STATE OF CONNECTICUT
CONNECTICUT SITING COUNCIL

APPLICATION OF CELLCO PARTNERSHIP)
d/b/a VERIZON WIRELESS FOR A)
CERTIFICATE OF ENVIRONMENTAL) DOCKET NO. 413
COMPATIBILITY AND PUBLIC NEED FOR THE)
CONSTRUCTION, MAINTENANCE, AND)
OPERATION OF A WIRELESS) February 2, 2011
TELECOMMUNICATIONS FACILITY LOCATED AT)
723 LEETES ISLAND ROAD IN THE TOWN)
OF BRANFORD, CONNECTICUT)

NEW CINGULAR WIRELESS PCS, LLC ("AT&T")
RESPONSES TO SITING COUNCIL INTERROGATORIES (SET ONE)

Existing Cellular Coverage

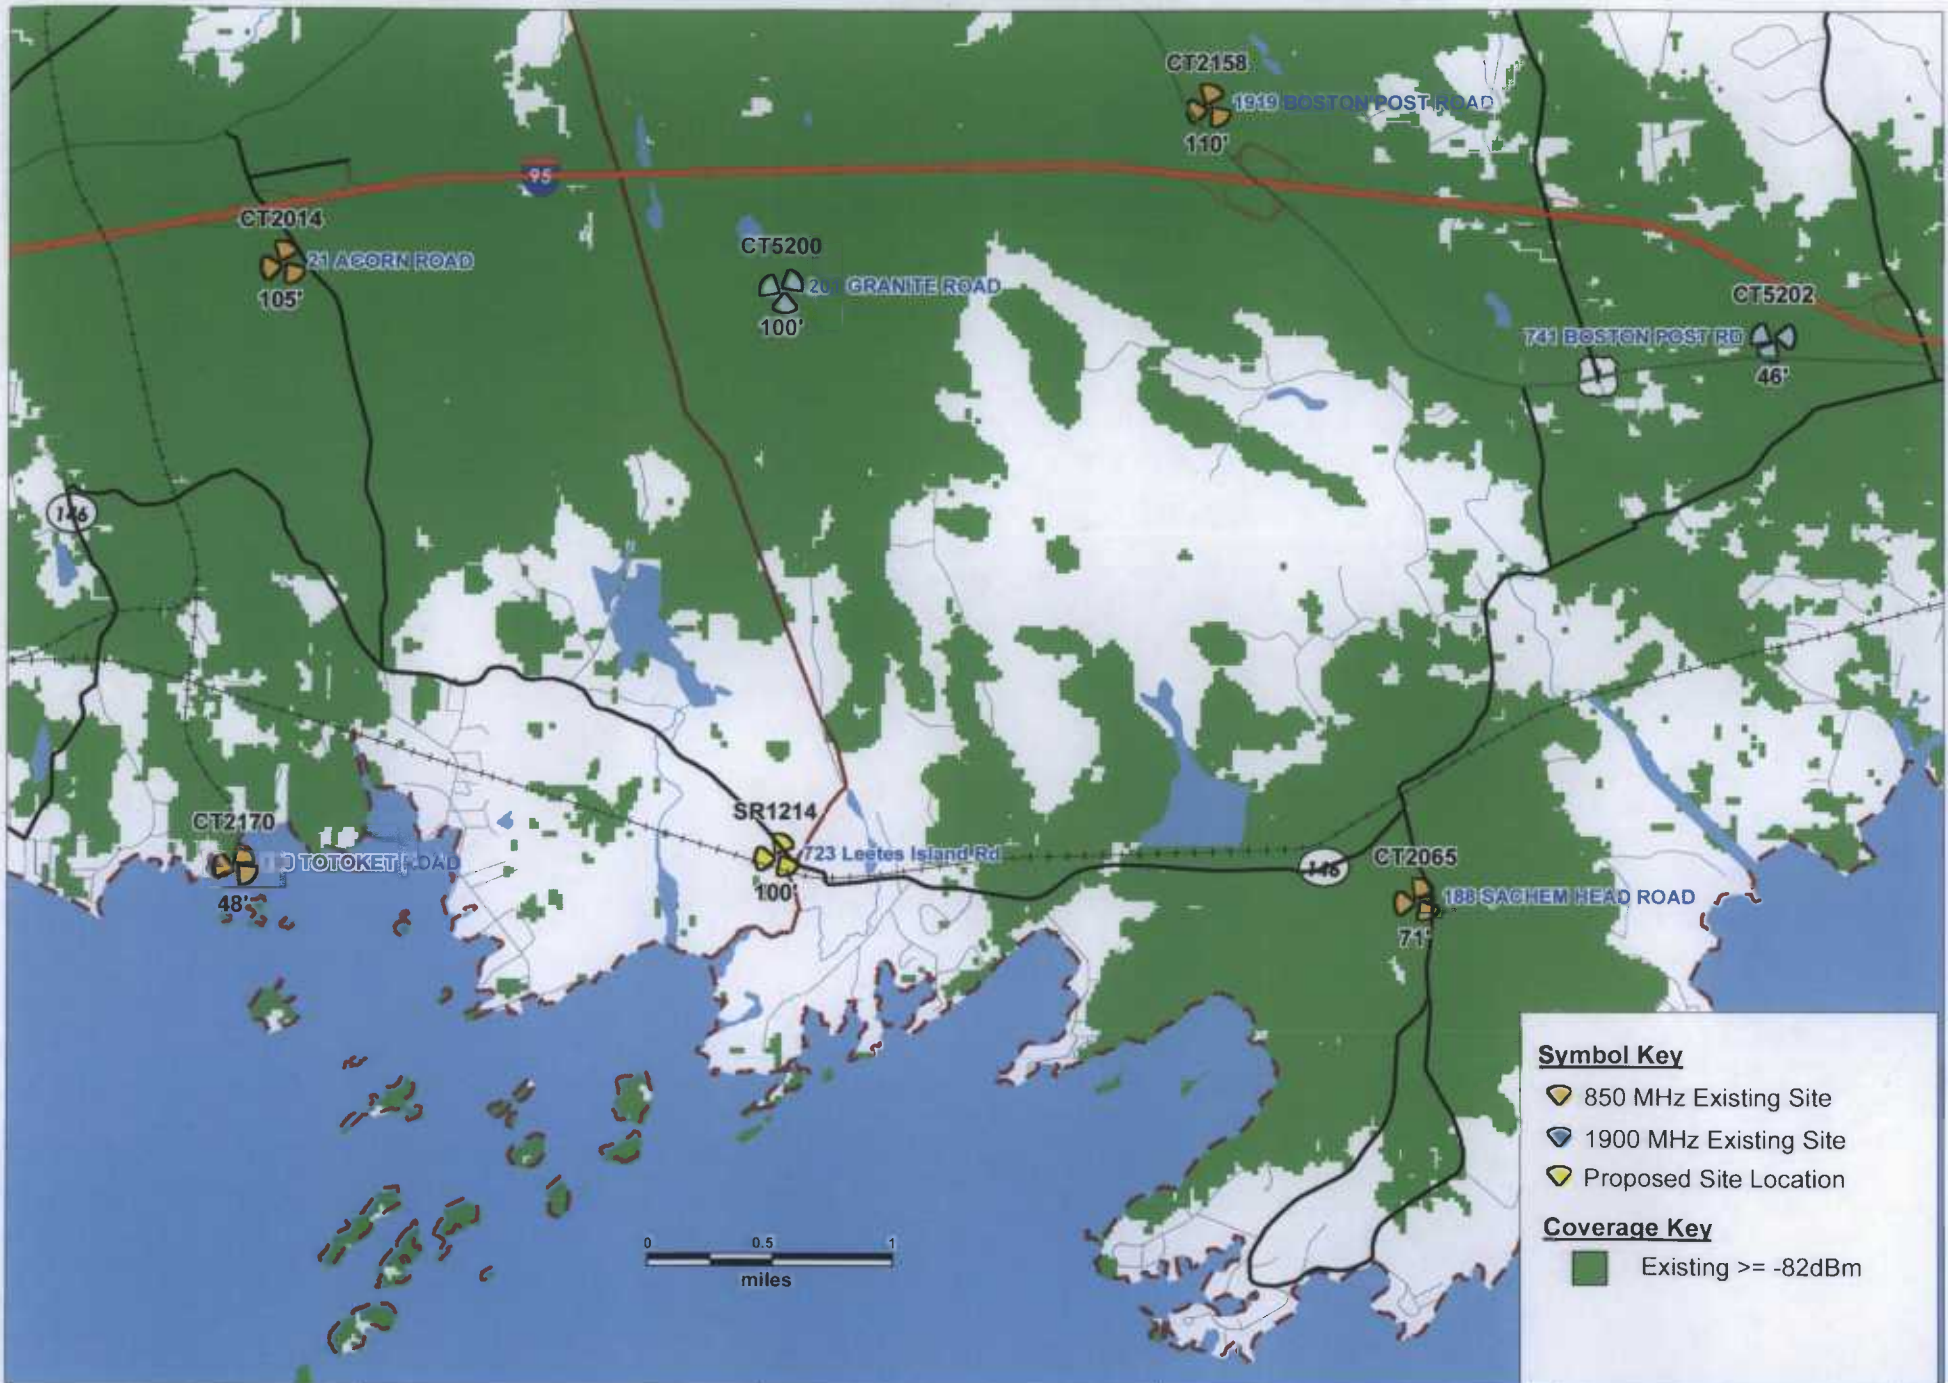
- Q5. For each of AT&T's licensed frequencies, provide propagation maps showing AT&T's existing coverage in the vicinity of the proposed facility and what AT&T's coverage would be with its antennas installed at their proposed height.

- A5. Attached in Exhibit B are:
- Propagation maps for 850 MHz (cellular) and 1900 MHz (PCS) frequencies showing AT&T's existing coverage in the vicinity of the proposed facility; and

Existing & Proposed
Cell @ 90 feet AGL

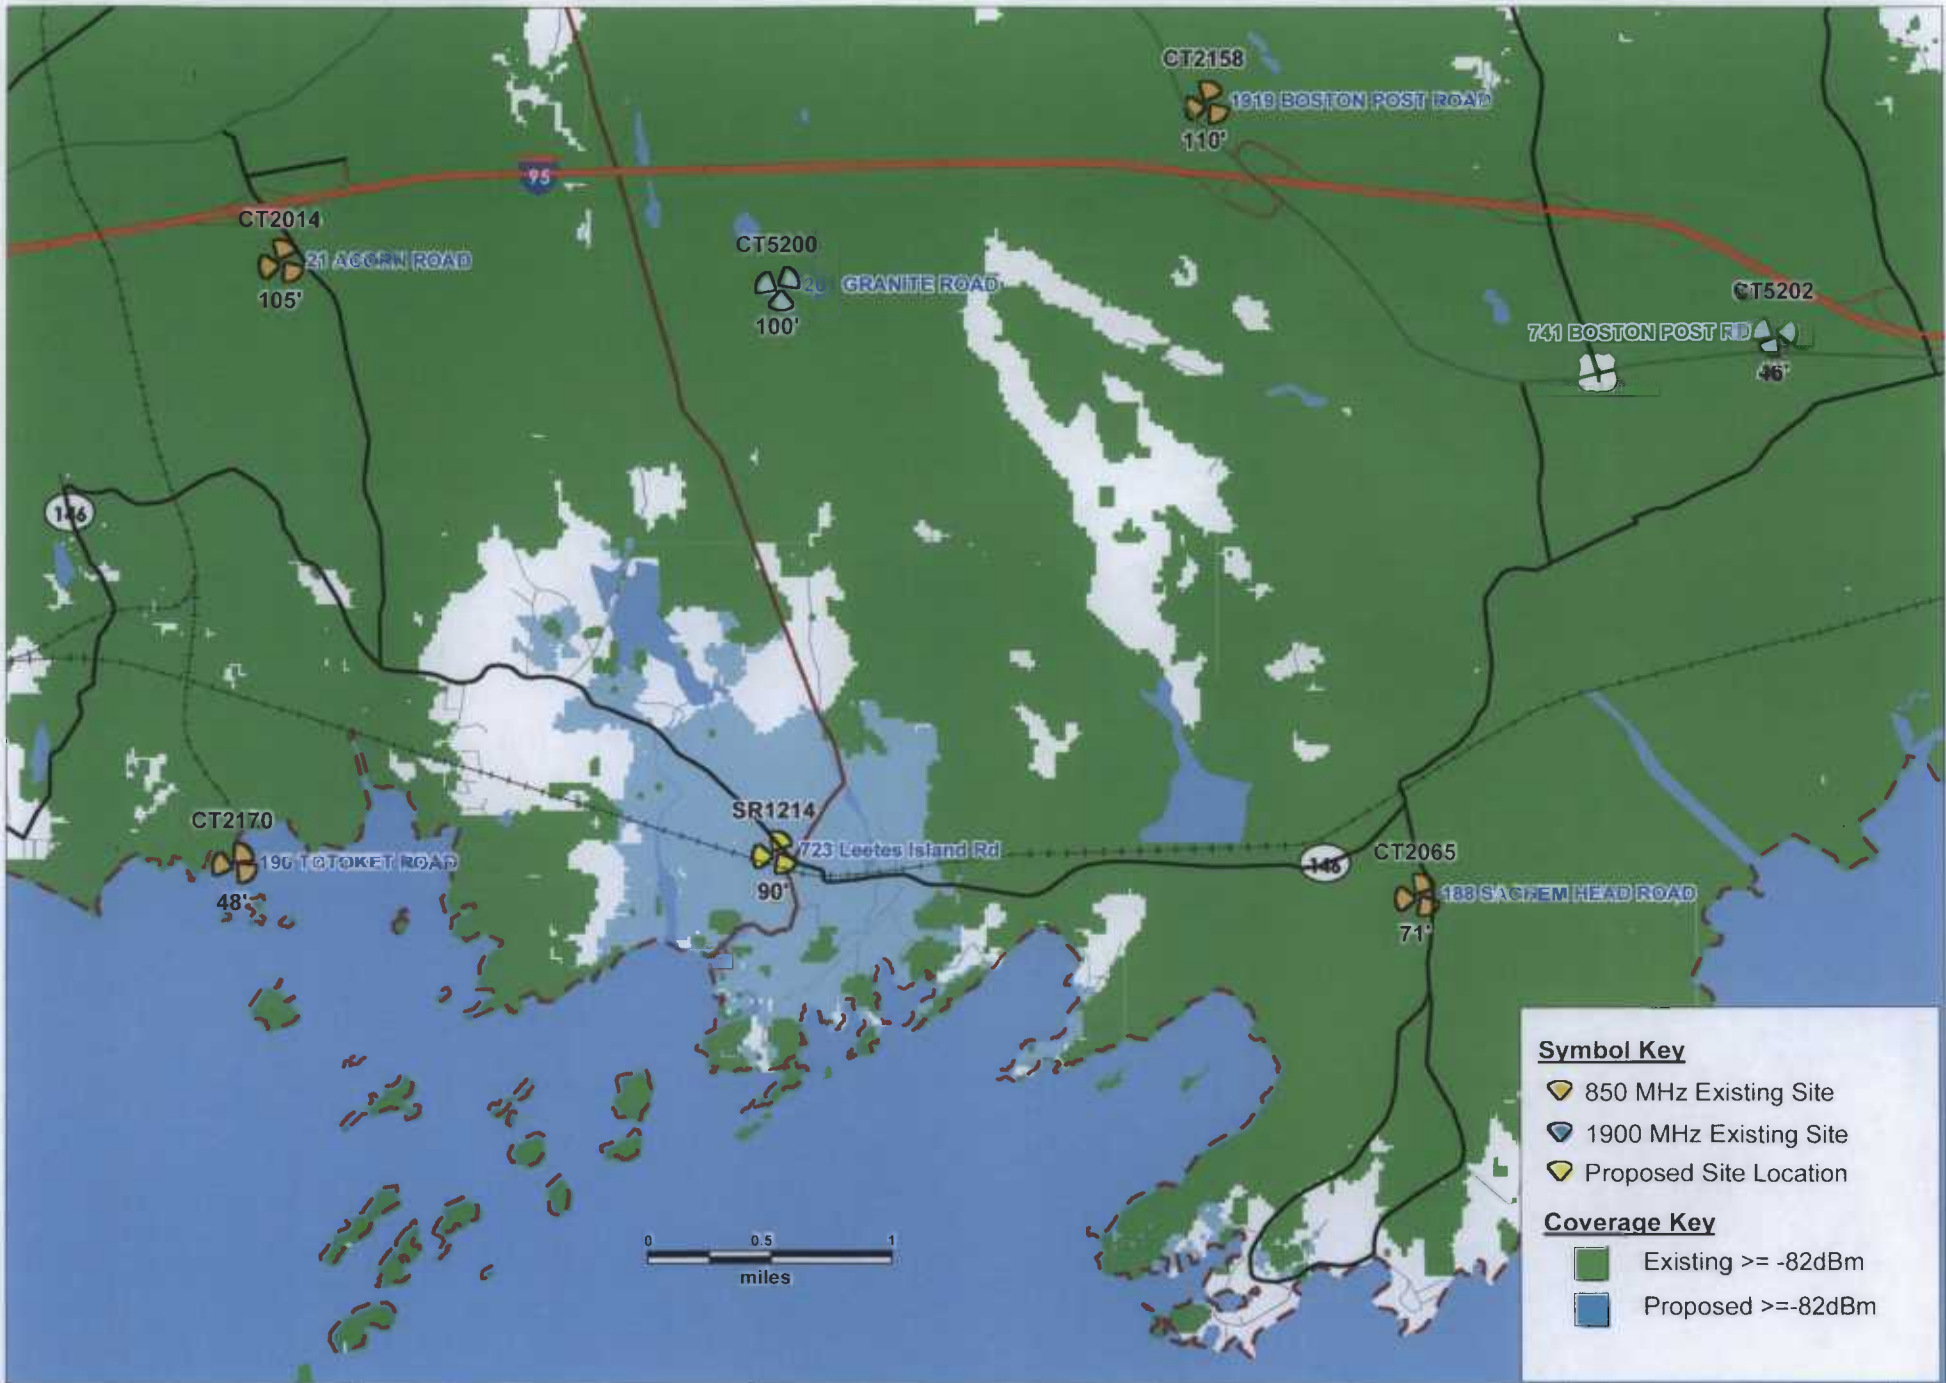
- Q6. What is the lowest height at which AT&T's antennas could achieve its coverage objectives from this site? Submit propagation maps showing the coverage at ten feet below this height.

- A6. AT&T's minimum height to achieve its coverage objectives from this site is 100' AGL. A propagation map showing coverage from 90' AGL is included in Exhibit C.
